PUR-1378
ADDENDUM NO. 2
INVITATION TO BID

THE MARYLAND THEATRE EXPANSION
IN HAGERSOWN, MARYLAND

DATE: Monday, March 26, 2018

A-6.11
2/15/18
BID SET

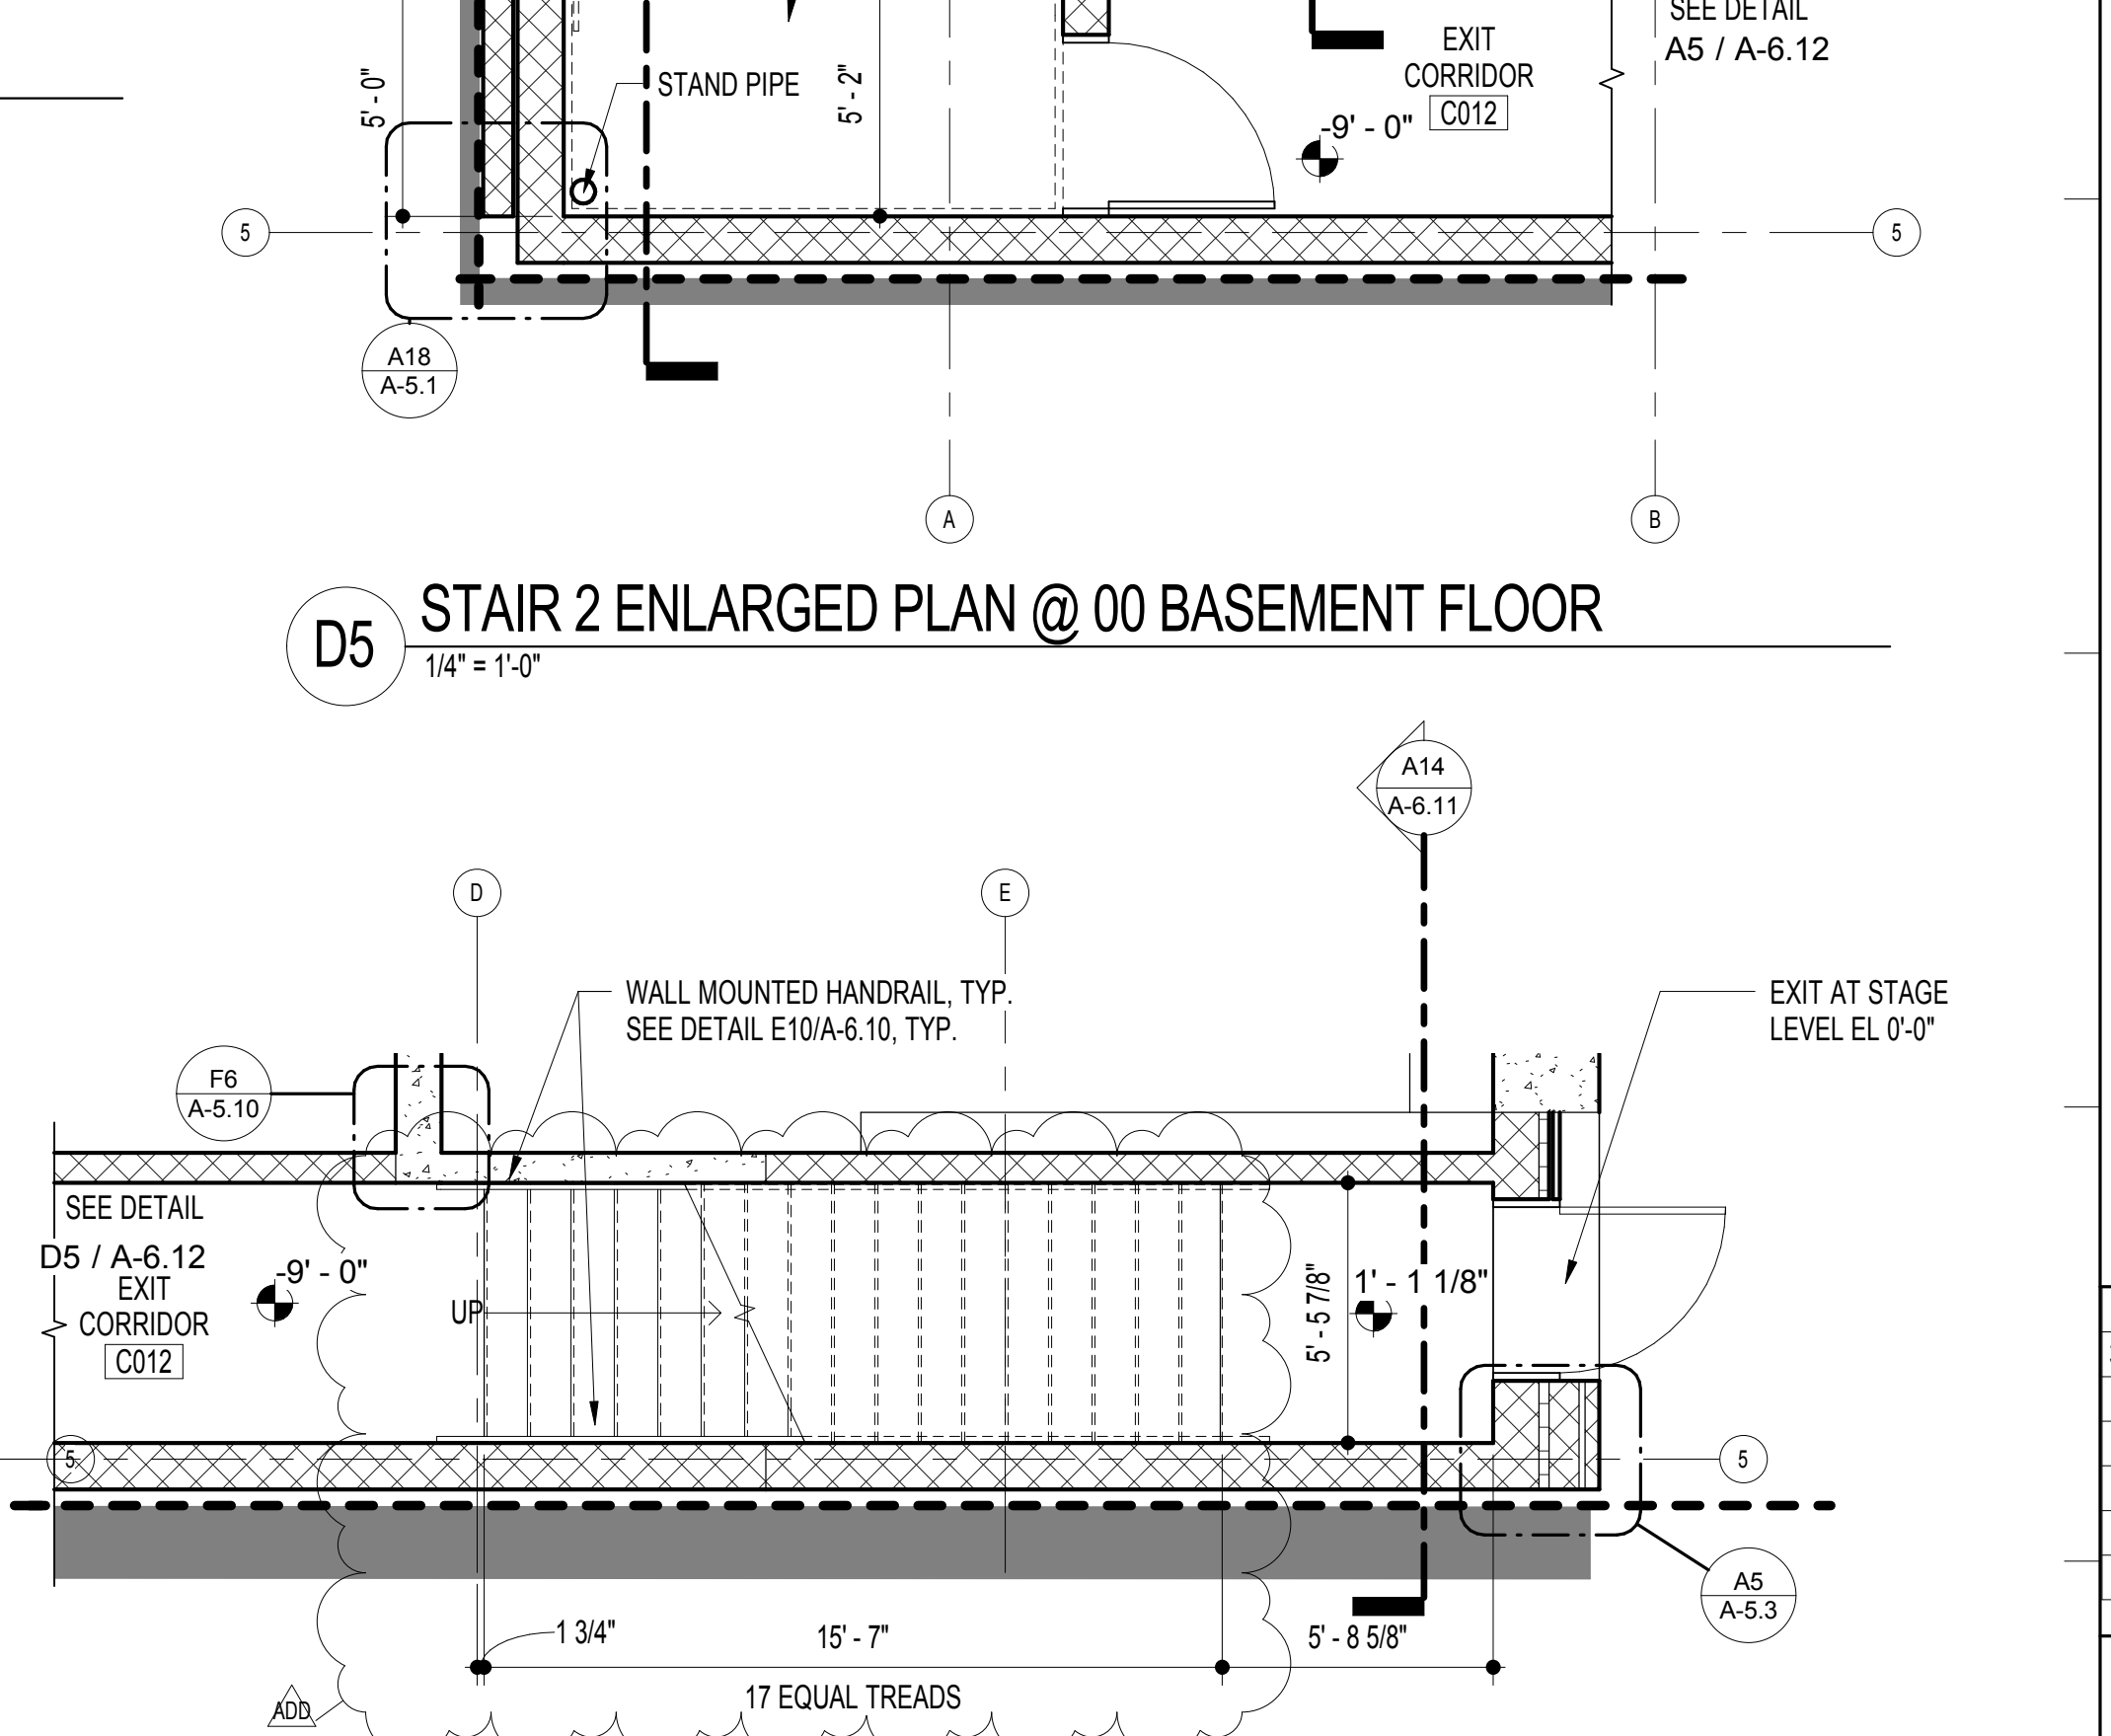
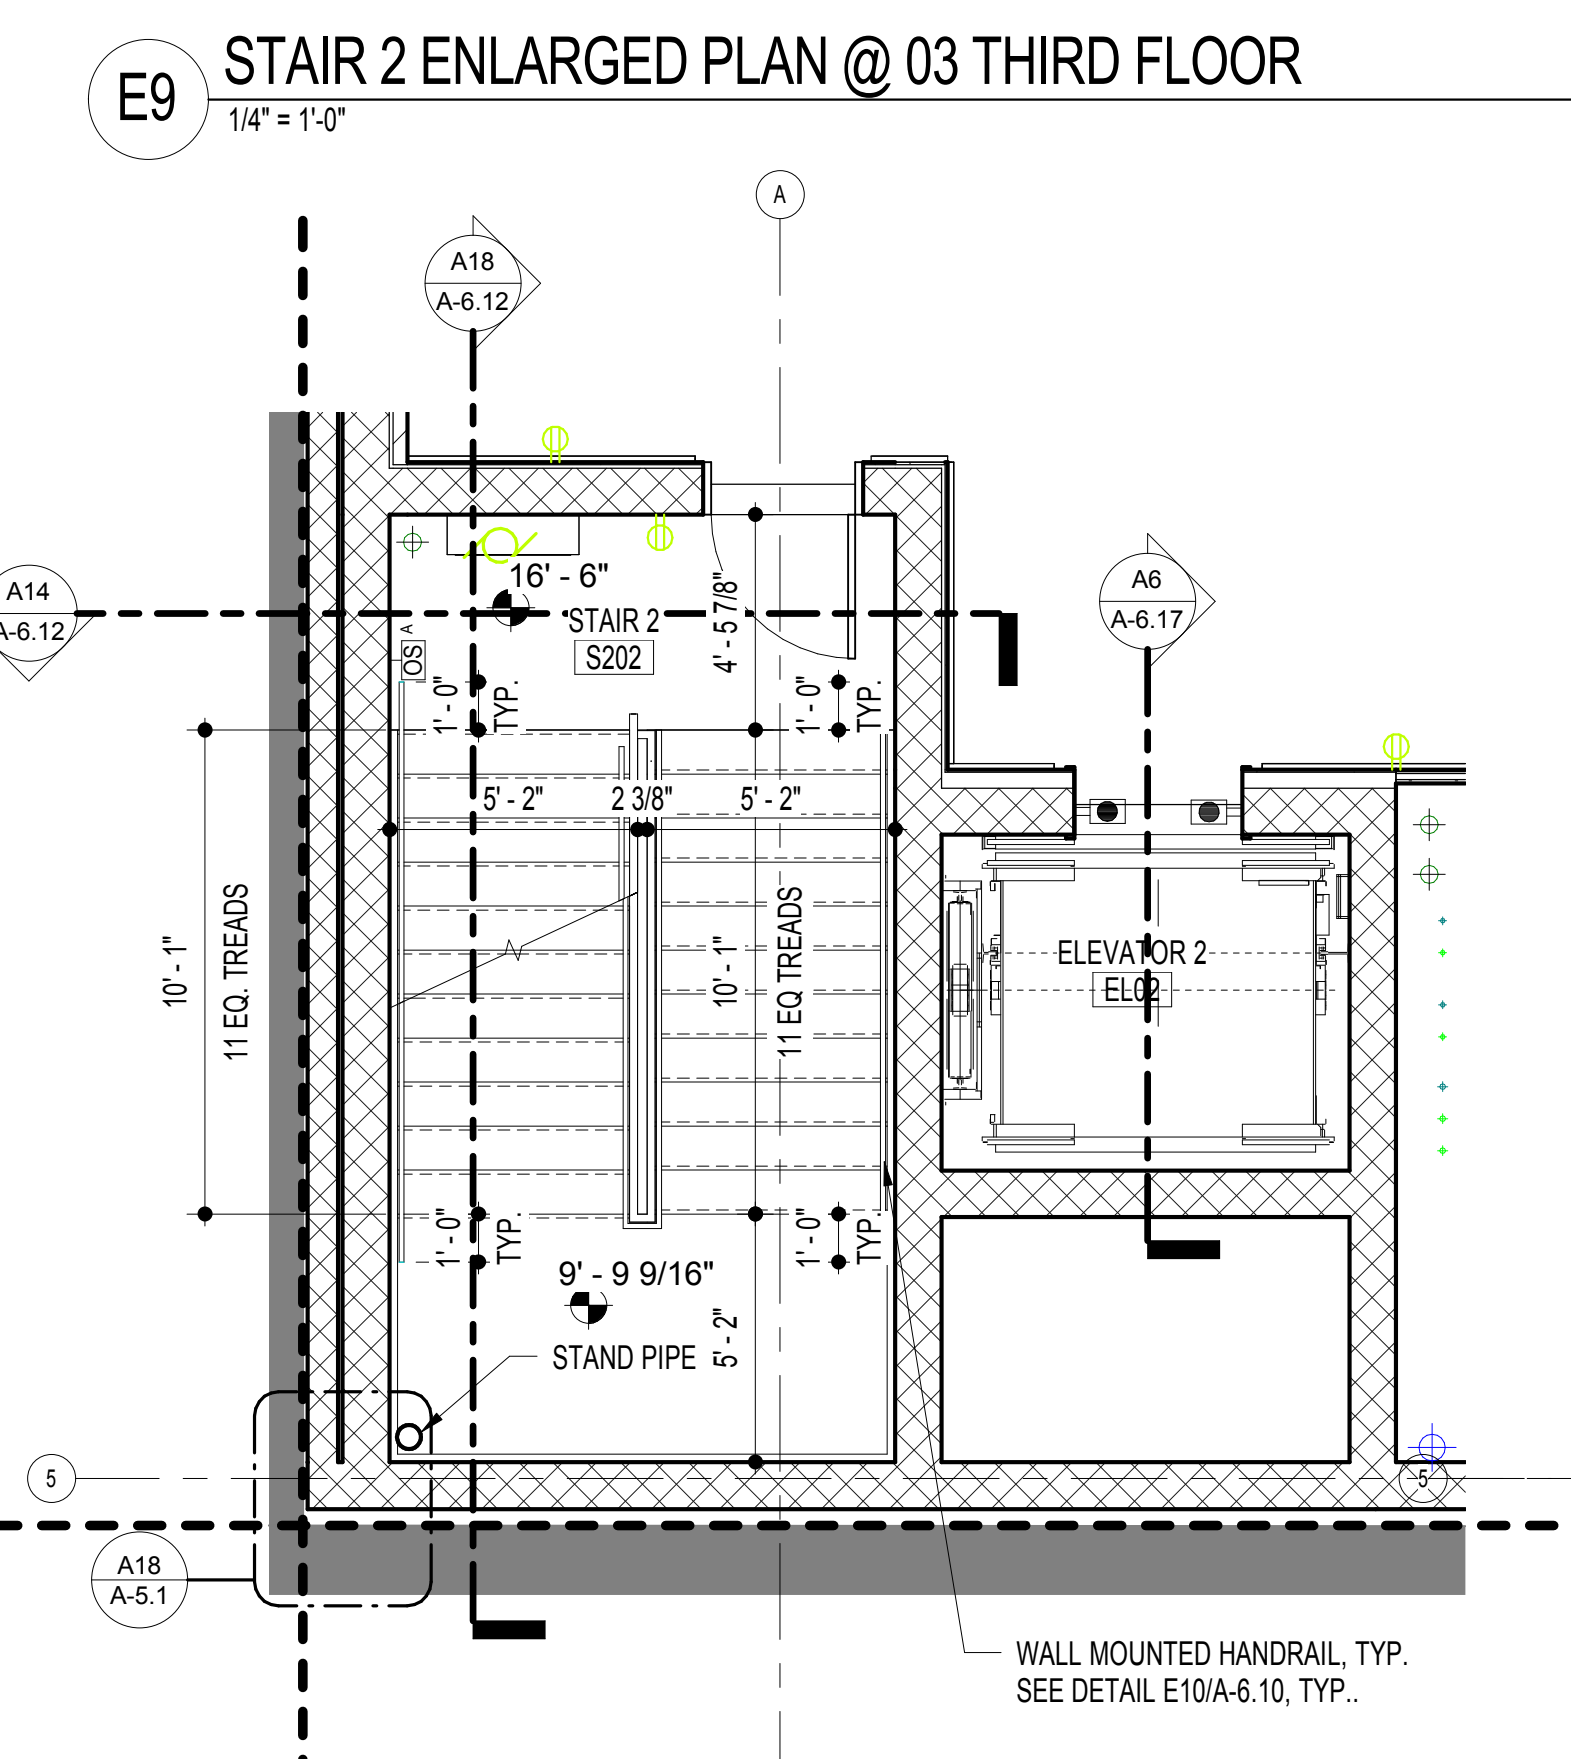
- ITEM NO. 100** SHEET A-6.11– STAIR 1 PLANS AND SECTIONS *(SHEET ATTACHED)*
- REMOVE** Remove 2 risers at Stair 1 to accommodate sidewalk elevations
- REVISE** Center Door EX100
